CODE COMPLIANCE CERTIFICATE

Consent No: 130599

Building Work		
Building Consent No:	130599	Issued by: Kāpiti Coast District Council
Project Description:	Erection of new single storey home with attached double garage on lifestyle block. Includes septic tanks & 2x 22,000 litre water storage tanks.

DRAINAGE PLAN	
Barry and Hayley Vinten Lot 117 - DP442630 Paraparaumu	
DRAWN BY ROD	CHECKED BY MARTY
GENERATION KAPITI COAST NZ	
DATE AUG 13	SCALE: 1:100 EC183 - dvg 11

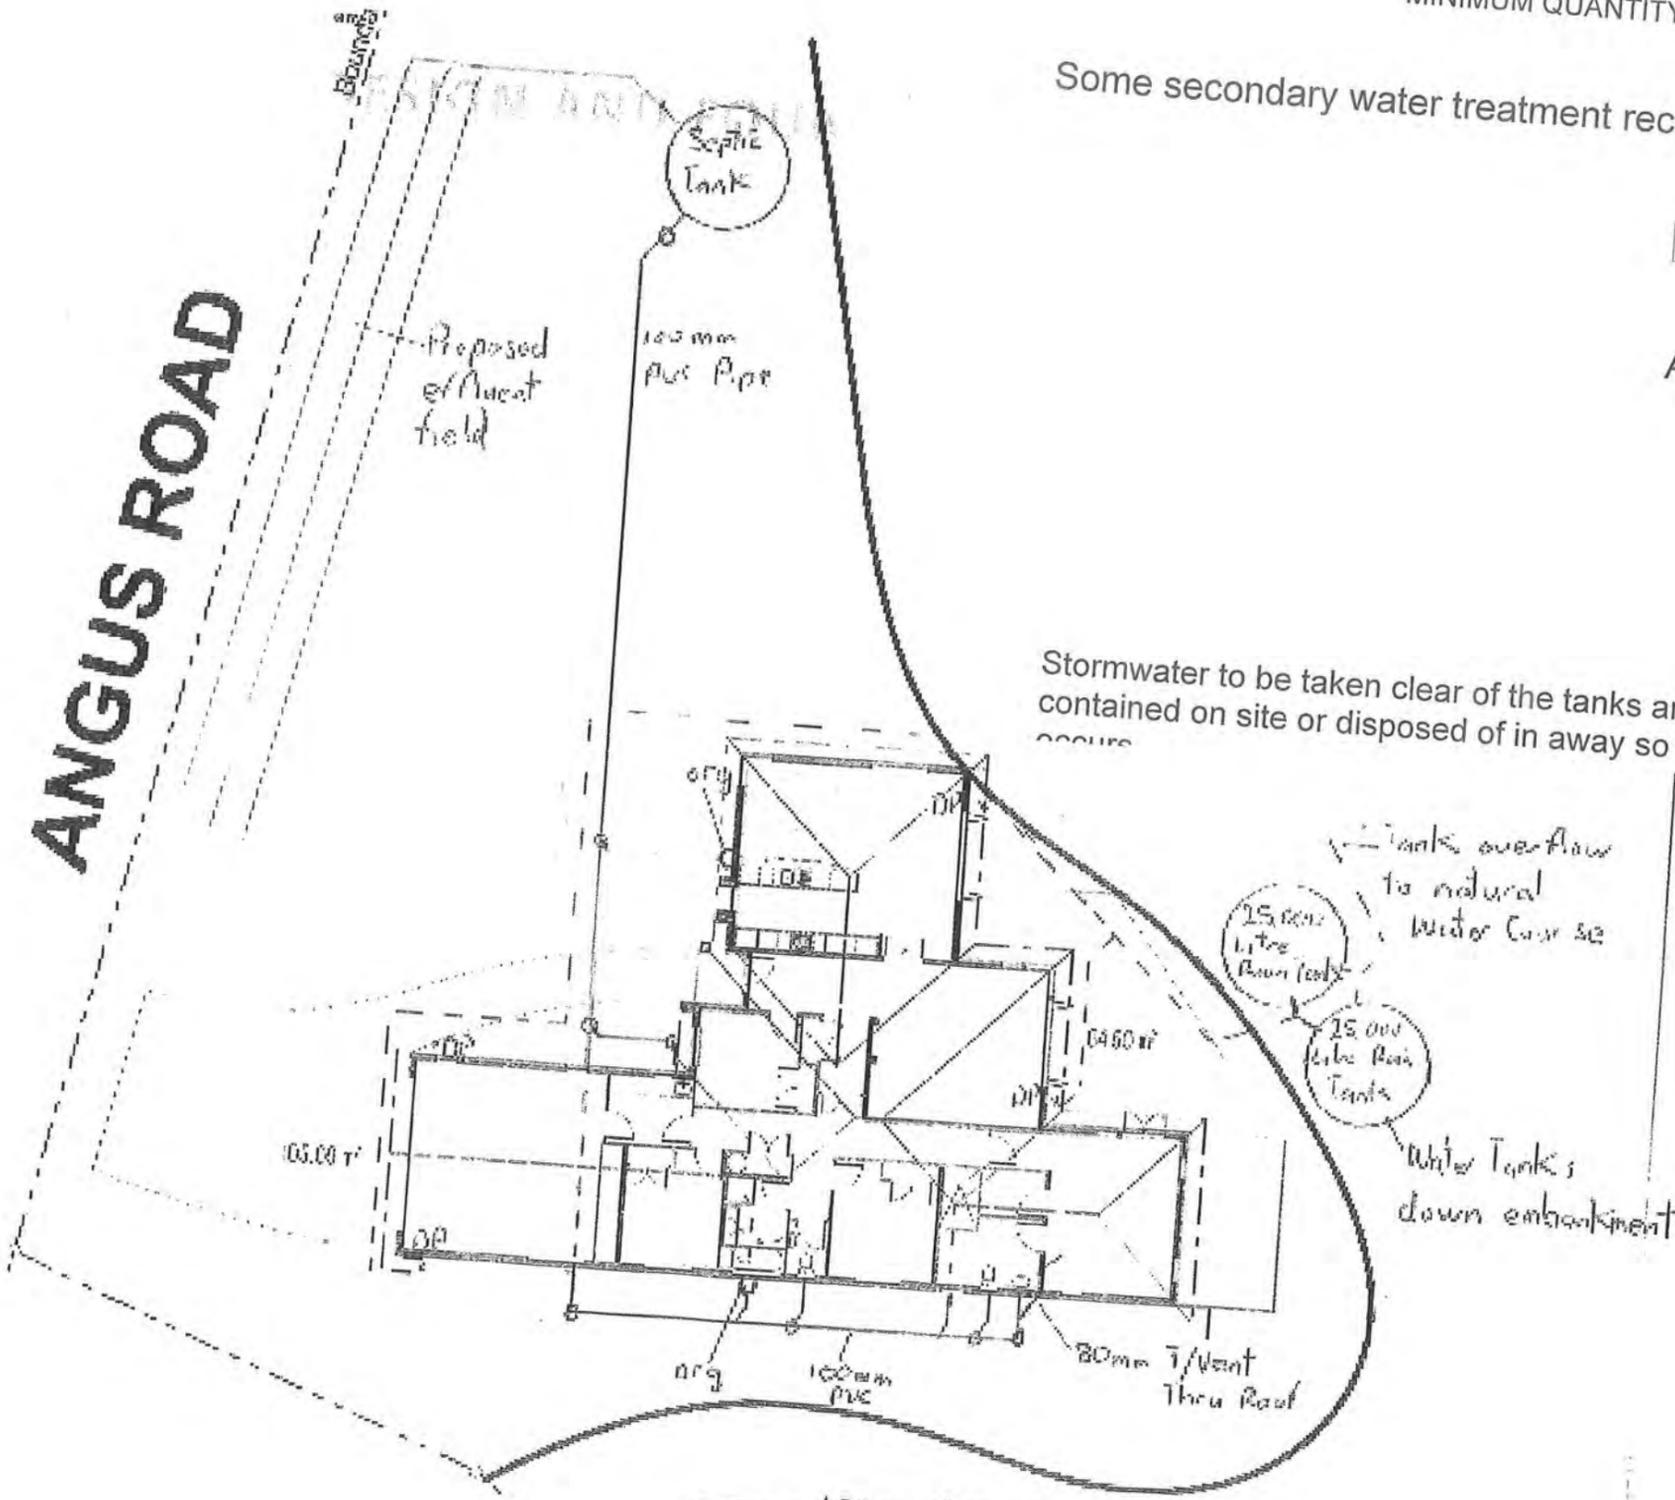
MAKE PROVISION FOR THE STORAGE OF POTABLE WATER
MINIMUM QUANTITY 30,000 LITRES

Some secondary water treatment recommended after first flush device

A drainage inspection is required

Stormwater to be taken clear of the tanks and the overflow be contained on site or disposed of in away so that no erosion occurs

BUILDER TO ENSURE THAT PROPOSED FOUNDATION HEIGHT WILL ALLOW A SATISFACTORY DRAINAGE CONNECTION TO THE SEWAGE TREATMENT SYSTEM

A 20MM copper TPR drain from the HWC is to run from the tundish to the discharge point at low level outside of the building at low level
Plastic pipe not to be used!

...ing plumber/drain layer is to fill out drainage producer statement form as near as laid drawing and return to Council. Please show all including under slab drainage

Site Plan	
Barry and Hayley Vinten Lot 117 - DP442630 Paraparamu	
DRAWN BY ROD	CHECKED BY MARTY
GENERATION KAPITI COAST NZ	
DATE AUG 13	SCALE: 1:200, 1:1000 183 - dwg 03

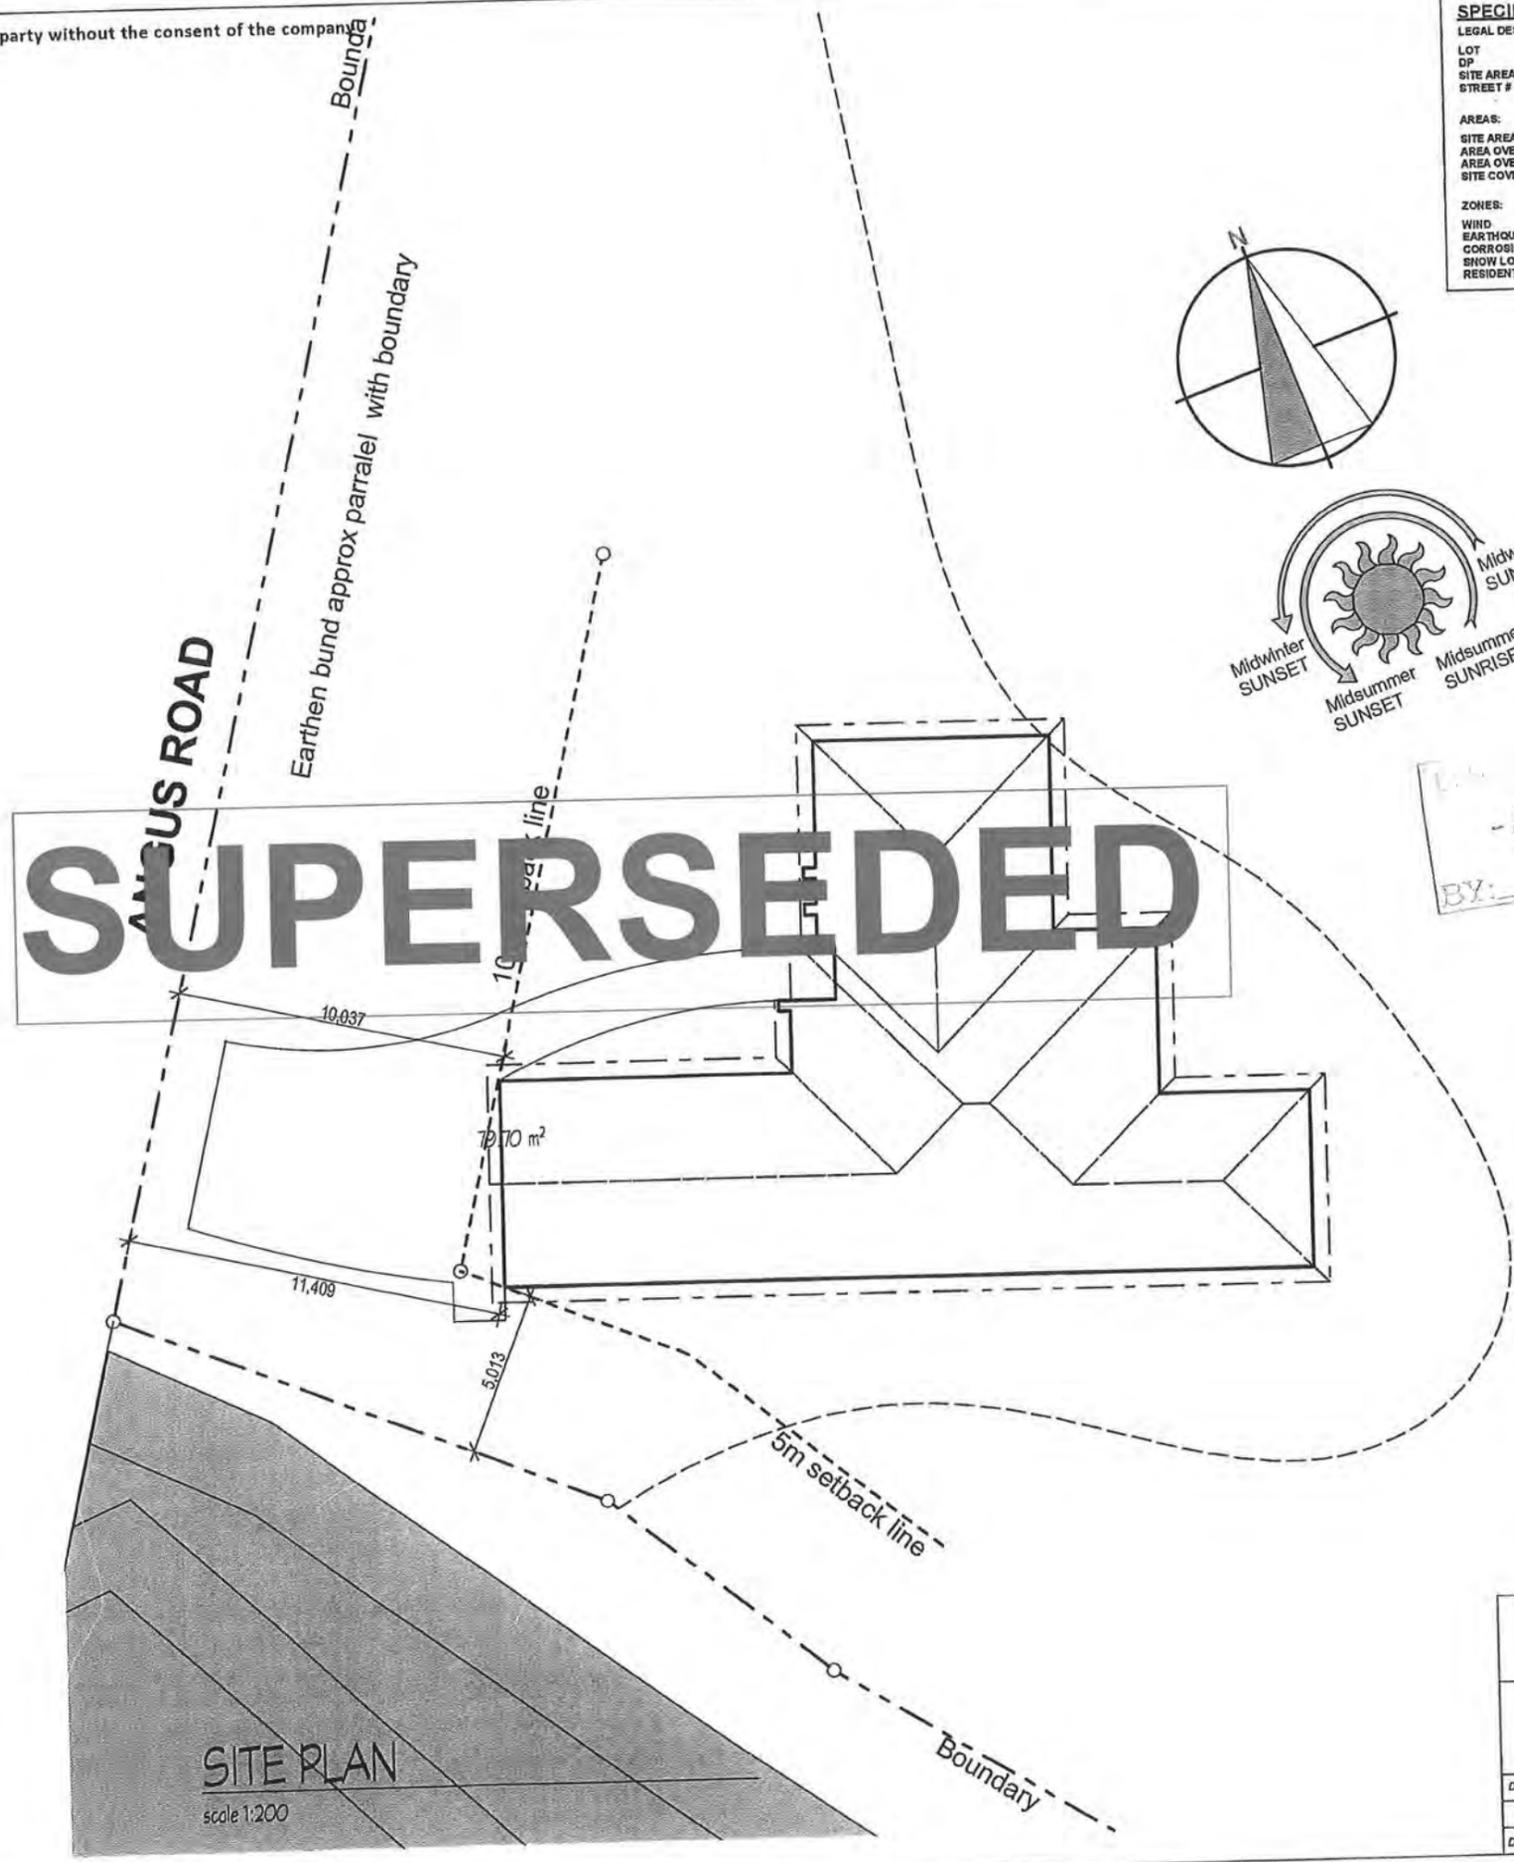
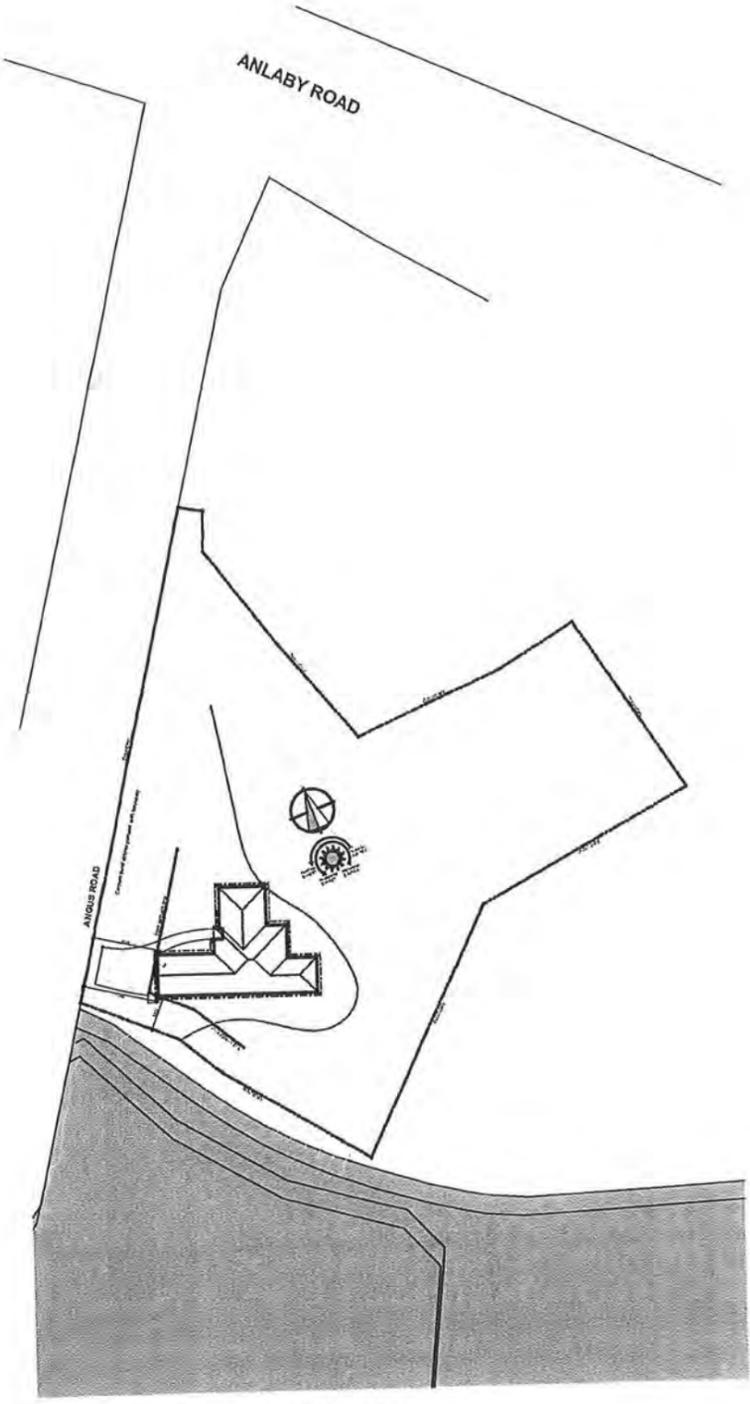
- 1) Please provide contours and ground work details. See revised Site Plan Sheet 3 now showing contours. I have spoken to our client Alan Pye and he advises the building will be sited on the level platform and no significant earthworks will be required other than the usual site scraping activity. The images attached show the platform to be quite level.

BRACING PLAN	
Barry and Hayley Vinten Lot 117 - DP442630 Paraparaumu	
DRAWN BY: ROD	CHECKED BY: MARTY
GENERATION KAPITI COAST NZ	
DATE: AUG 13	SCALE: 1:100
EC183-dwg 12

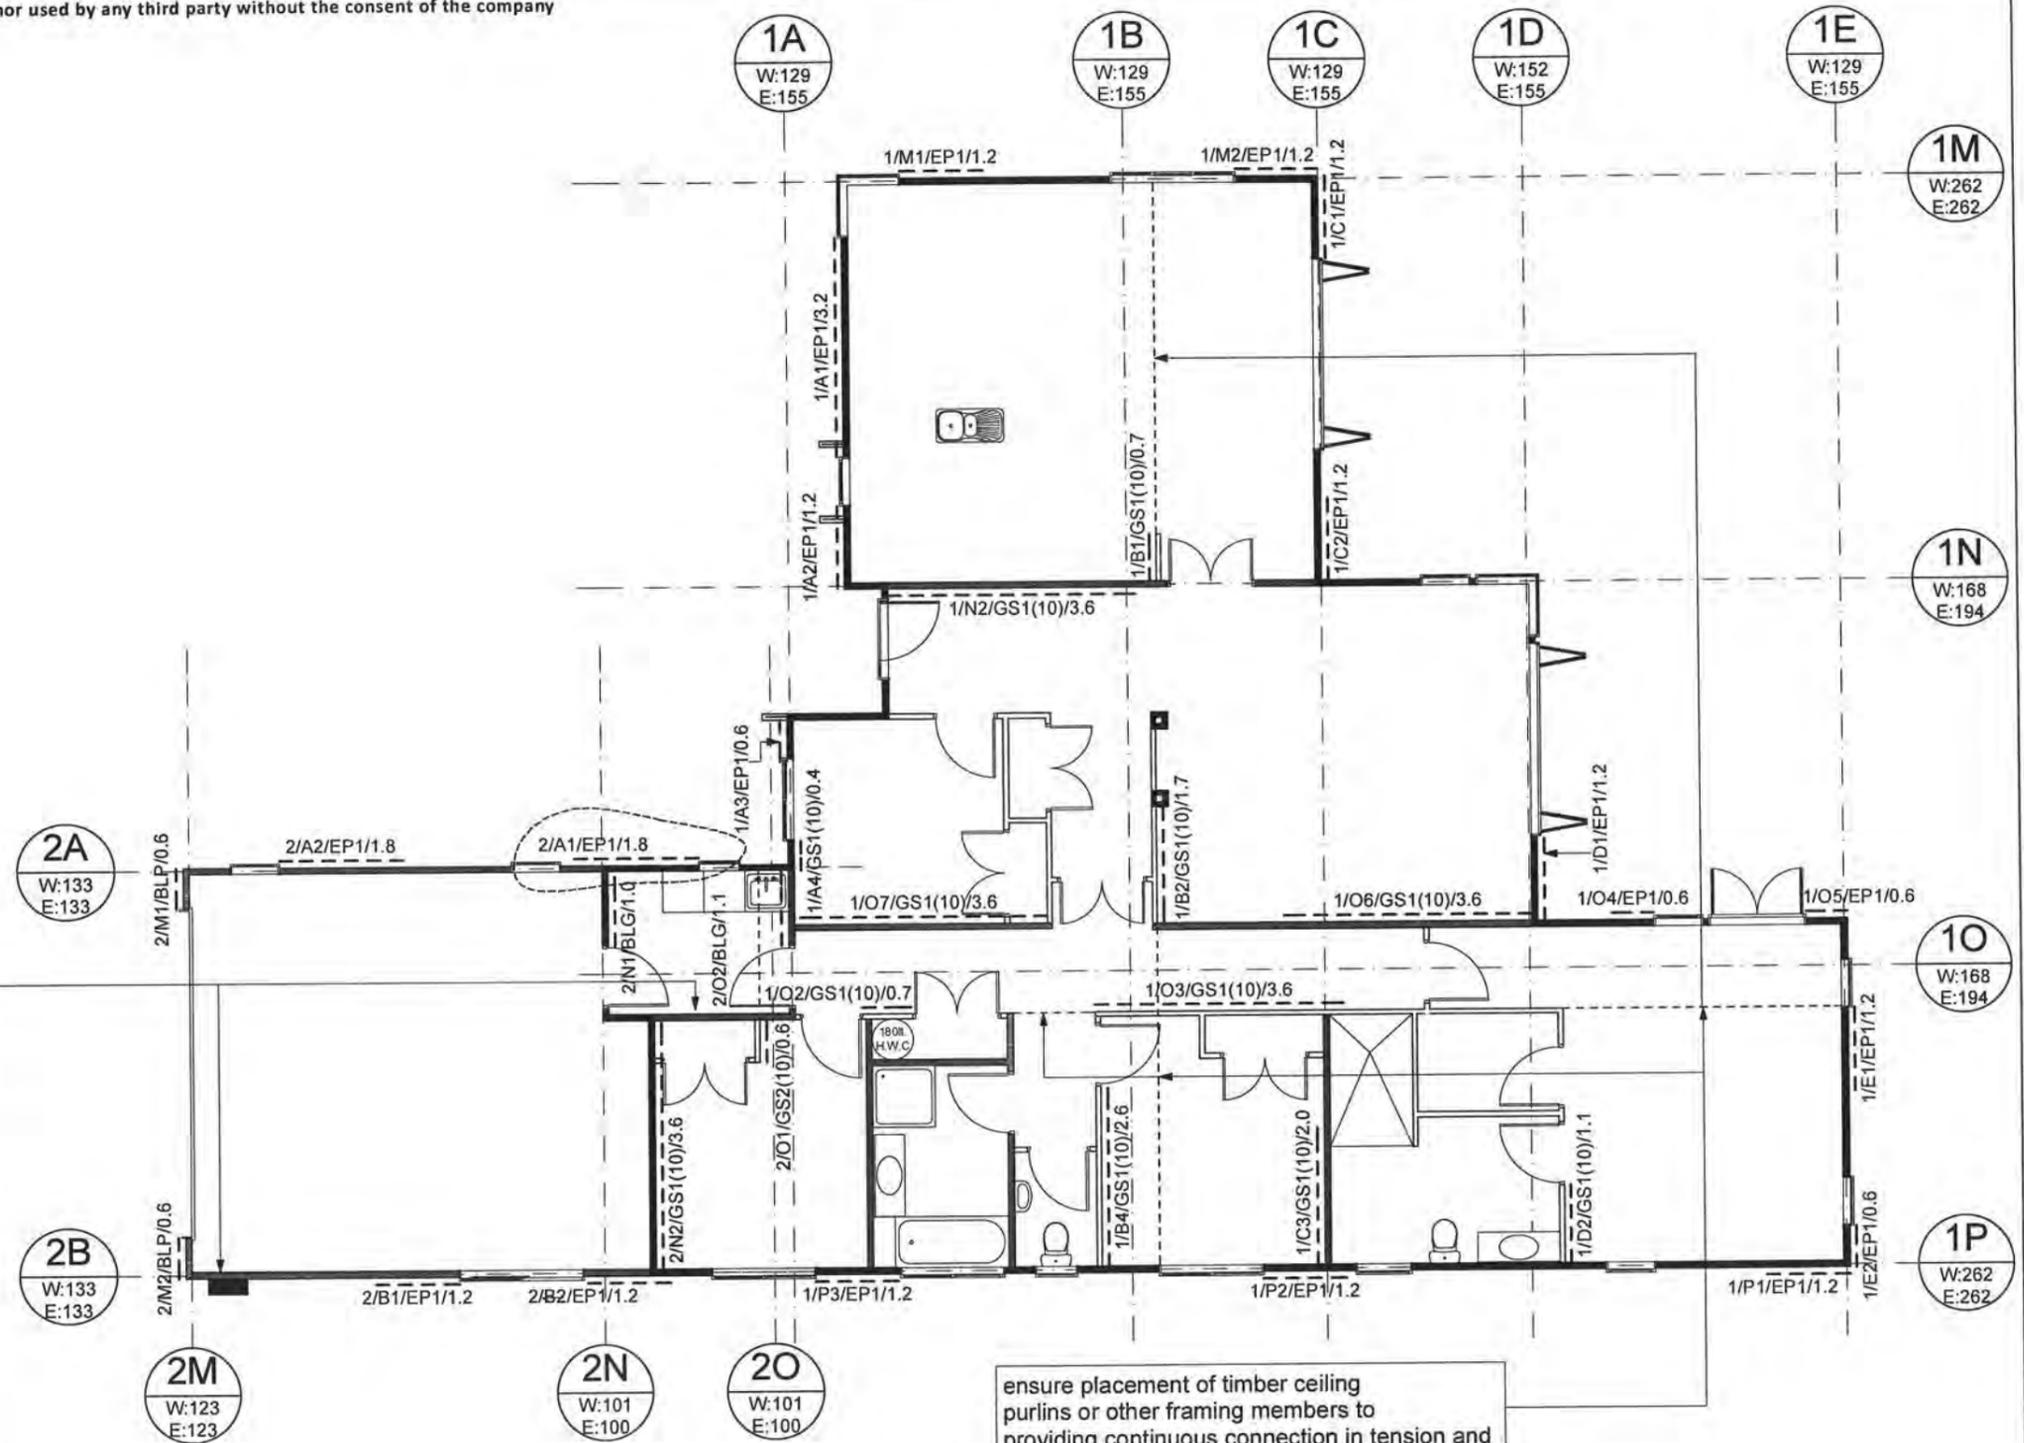
- 3) Please provide the following weather tight details; a) Window head, Jamb and sill, b) meter box and garage. See Attached new sheet 23
- 4) Bracing Calculations for very high wind zone; a) the bracing factors within the calculations do not appear to correlate to table 5.5 of NZS 3604:2011 for wind, b) the EP1 bracing values for wind appear higher than the manufacturers specifications- please revise. See Attached revised sheets 12 & 13 item (a) resolved as discussed earlier.
